Dear Valued Customer,

We recently sent you a letter that explained three critical problems we found with the CLICK Programming software. Koyo has modified the software to correct those problems. The new version is V1.12.

1. Descriptions of the problems and solutions

Problem 1: Coil and Box instructions may be activated unexpectedly when there are three or more branches.

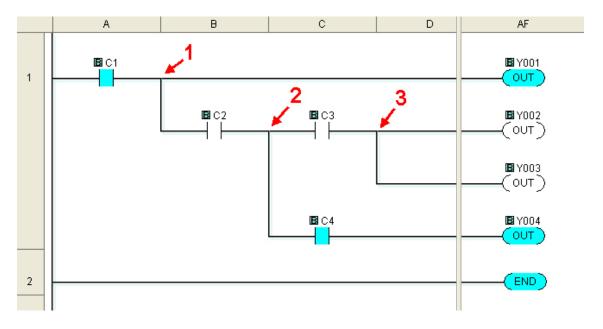
Please refer to the following example program. There are three branches indicated with the numbers 1, 2 and 3. Even if the contact with C2 is off, the Output instruction with Y004 is activated.

This problem was fixed in the latest version V1.12 of the CLICK Programming software. The above ladder program can be downloaded into the CLICK PLC and it works correctly.

Problem 2: Coil and Box instructions may be activated unexpectedly when there is a vertical line.

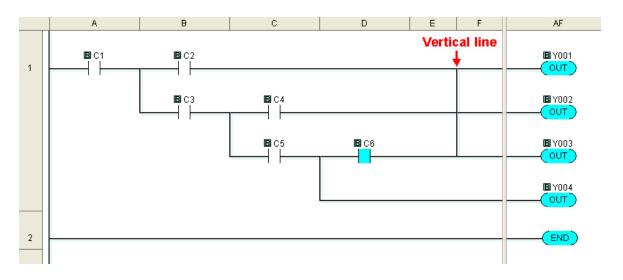
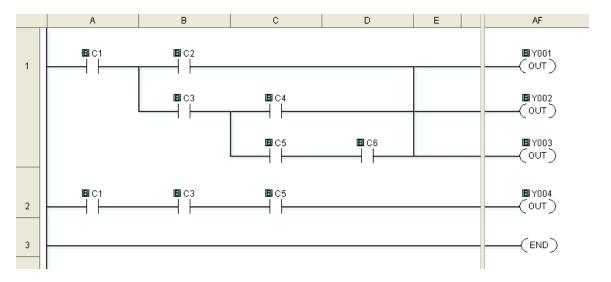
Please refer to the following example program. There is a vertical line between the column E and F. When the contact with C6 is on, all Output instructions with Y001 to Y004 are activated.

The latest version V1.12 of the CLICK Programming software flags the above ladder program as a syntax error. This ladder program can't be downloaded into the CLICK PLC. In this case, split the Rung #1 into 2 rungs as follows.

Problem 3: Coil and Box instructions may not work correctly when the For instruction is used in a rung with branches.

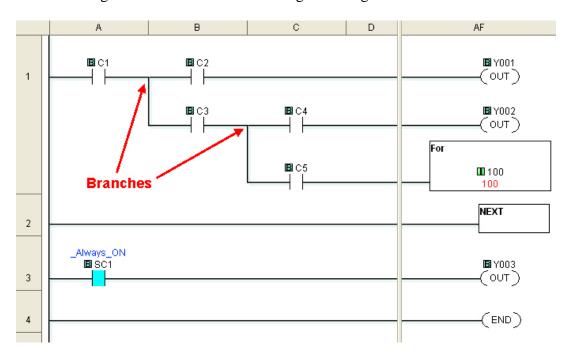
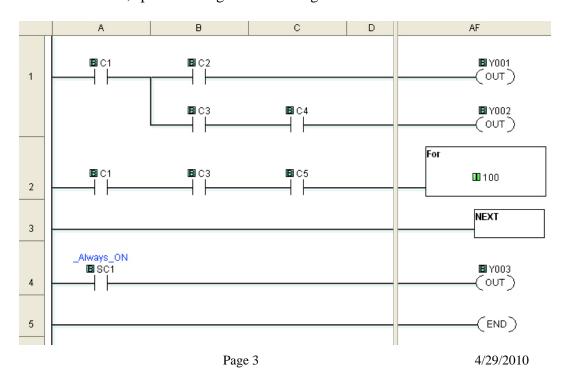
Please refer to the following example program. The first rung has two branches and a For instruction. The For-Next loop finishes at Rung #2. However, the Output instruction Y003 on Rung #3 is not activated even though the rung status is true.

The latest version V1.12 of the CLICK Programming software flags the above ladder program as a syntax error. This ladder program can't be downloaded into the CLICK PLC. In this case, split the Rung #1 into 2 rungs as follows.
